Service Bulletin 28

(a) Service Bulletin No:	28
(b) Revision / Date	2 / 04-March-2020
(c) Title:	Stratus Double Burner, Burner Hanger Inspection
(d) Description:	Inspection / Replacement of Stratus Double Burner Hanger.

SB28: Accomplishment Instructions.
Stratus Double Burner; Mounting Hanger Inspection.

CBL/TN/DCB/3191

Fig 3. Burner Serial Number (296) & Part Number (CB8720) engraved on the hanger

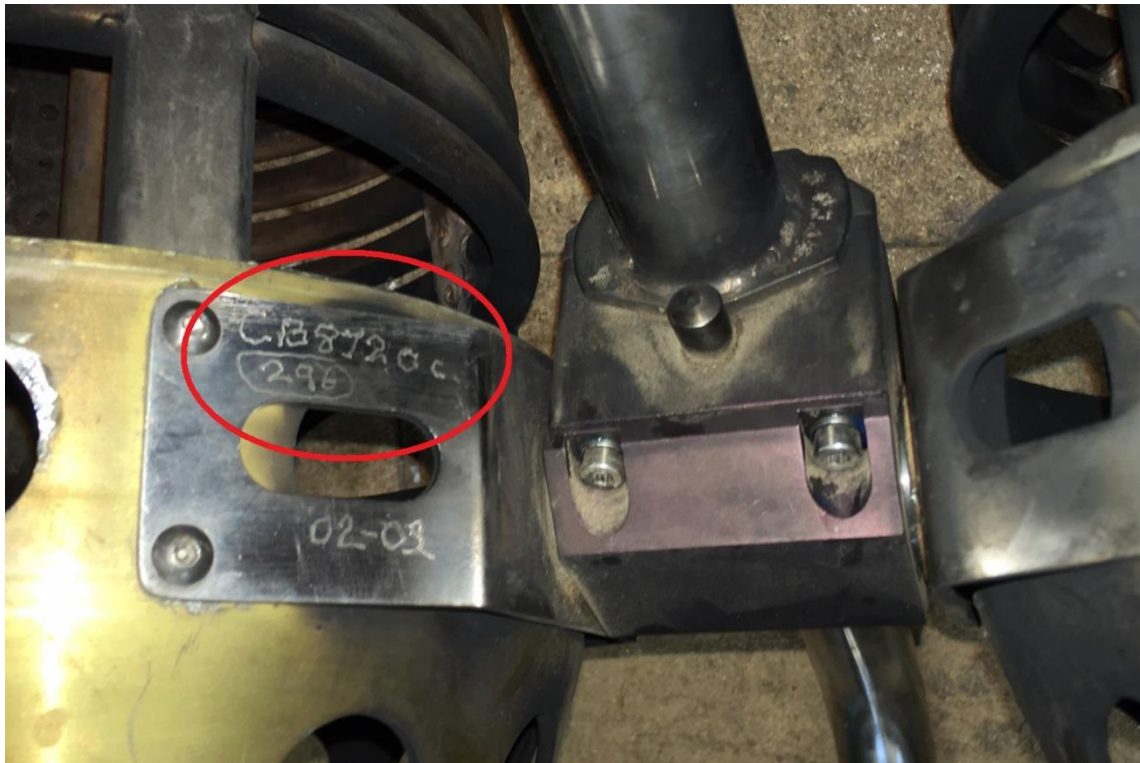
- 2.1.1 The affected hangers were fitted to double burners with serial numbers 320 or lower. The burner serial number is hand engraved onto one of the hanger end plates. Should the burner serial number be unreadable or missing Cameron Balloons can identify the burner from the manifold block serial numbers (machine engraved onto the upper surface of the burner manifold block).

Fig 4. View of Hanger Assembly.

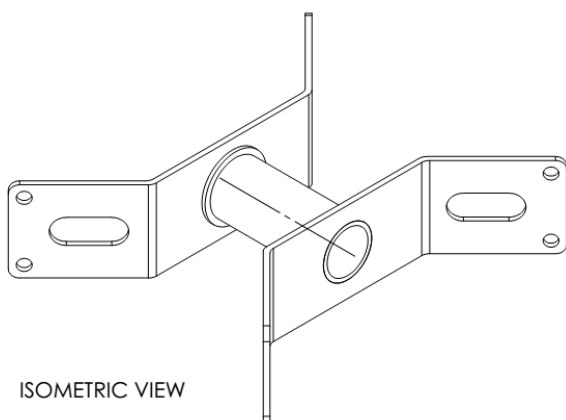
2.1.2 Affected hangers (Issues A through C) have either no machine engraving or have “Cameron Balloons Limited” machine engraved in the upper right-hand corner of the end plate. Non-affected hangers (Issue D and E) have the text “Cameron Balloons Limited” machine engraved in the lower right-hand corner of the end plate.

Fig 6. View of the affected weld. Note burner coil removed for clarity.

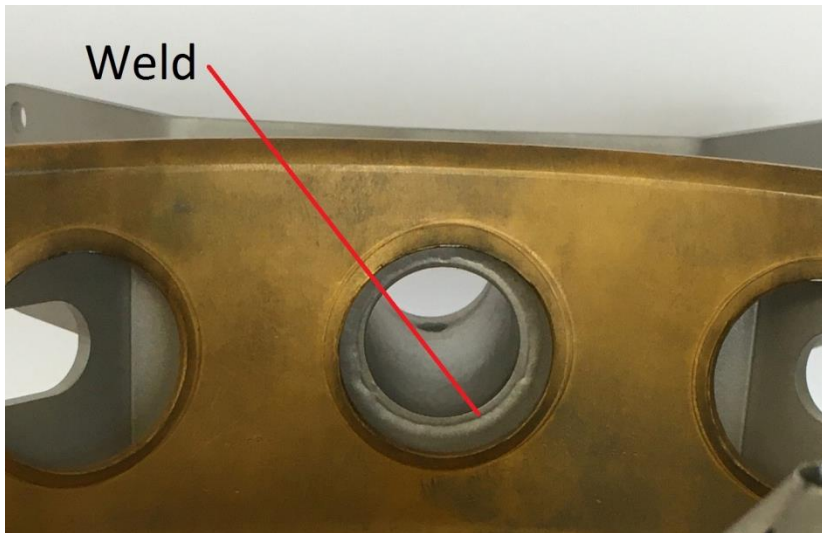
- 3.1.1 The weld in the end of the hanger can be seen through the holes in the can. A torch and a mirror may be required to give a clear view.
- 3.1.2 Remove any soot or dirt prior to inspection. WD40 or kerosene (paraffin) is the preferred cleaner; some solvent cleaners may damage the finish of the can.
- 3.1.3 Inspect the weld for any signs of cracking. Attempting to move the burner relative to the hanger may assist in making the crack visible.
- 3.1.4 If a clear view cannot be obtained or there is any doubt then the hanger must be removed from the burner. The burner is mounted to the hanger with M5 fasteners CY-0005-1004, CY-0005-1016, and CY-0005-2009. A single M3 screw secures each burner manifold block to the tubular handle.
- 3.1.5 Cracked hangers must be replaced before further flight with a new part CB-8504-0000 Issue D or later. **Cracked hangers must not be re-welded.**
